**COAL ASH IMPOUNDMENT
SITE ASSESSMENT FINAL REPORT**

**Meredosia Power Station
Ameren Energy Generating Company
Meredosia, Illinois**

KLEINFELDER PROJECT NUMBER 112618-7

May 10, 2011

PROJECT NO. 112618	<p align="center">TYPICAL CROSS SECTION BOTTOM AND FLY ASH PONDS</p> <p>MEREDOSIA POWER GENERATING STATION 800 SOUTH WASHINGTON STREET MEREDOSIA, IL 62665</p>	FIGURE
	DATE: 08/19/10		<p align="center">3</p>
	DRAWN BY: MAG		
	CHECKED BY: BDH		
	FILE NAME:

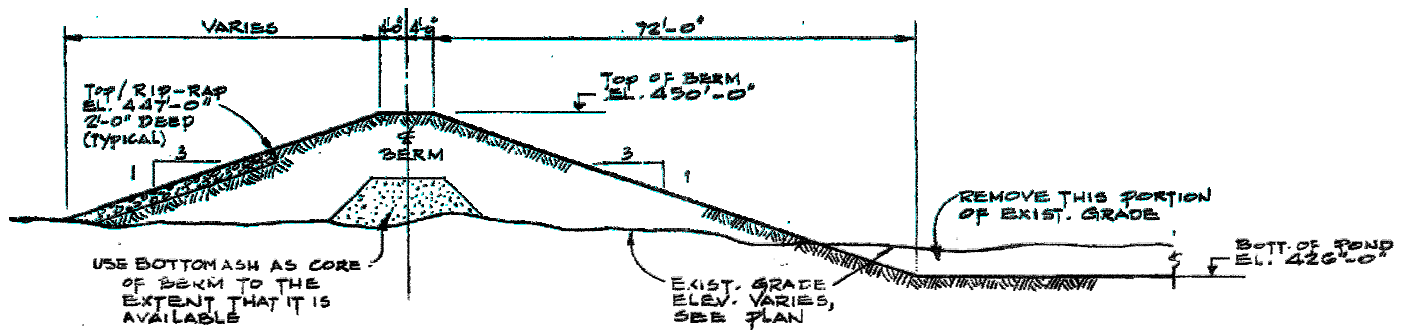
- The upstream slope was laid back at approximately 1.5H:1V, based on visual observations. This varies from the construction documents provided by Ameren, probably due to the build-up of bottom ash on the embankment. However, it is possible that cleanout operation at the Bottom Ash Pond could have cut into the embankment and steepened it over time.
- Minor erosion rills, less than 6 inches deep, were noted on some of the upstream slopes.
- Grasses and woody bushes were observed on the upstream slope for the majority of the impoundment.
- Mowing/Vegetation control had not been completed on the majority of the upstream slope.

- The upstream slope was laid back at approximately 3H:1V
- Mowing had not been completed on the majority of the upstream slope.
- Grasses, bushes and woody debris were observed on the slope.
